knitter-switch

Product-Change Notification

Products affected: KTT 107
KTT 204, KTT 206, KTT 208, KTT 209, KTT 217, KTT 227

Effective date: from date-code 1237 (week 37, 2012)

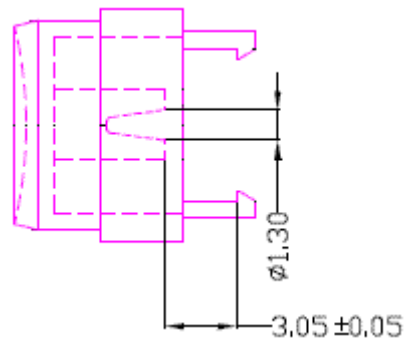
Due to a change of tolerances on assigned switches (TMP-series) the caps needed to be modified in the same way. The dimension 2.8 mm changes to 3.05 mm:

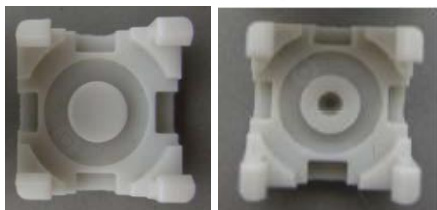
For easy visual identification of old and new version, the new caps have a 1.3 mm hole inside:
